WAUKESHA PUBLIC LIBRARY

Date: September 30, 2020

To: Library Board Building Committee From: Bruce Gay, Library Director Re: Front Entry repair options

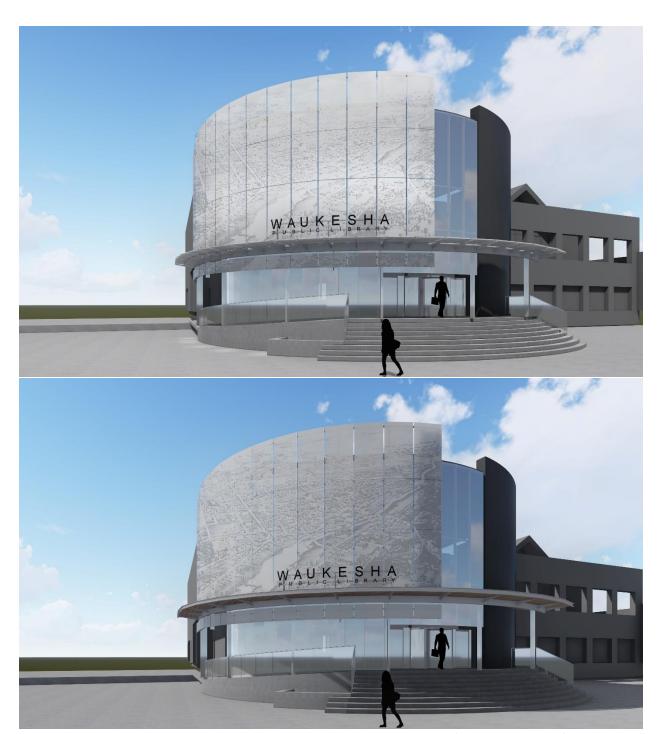
2. This image replaces the horizonal resin panels with a solid canopy, more like a traditional roof. Lights are included shining down from the canopy. This option reduces the cost by **\$64,474**. It also makes lighting the library sign simpler.
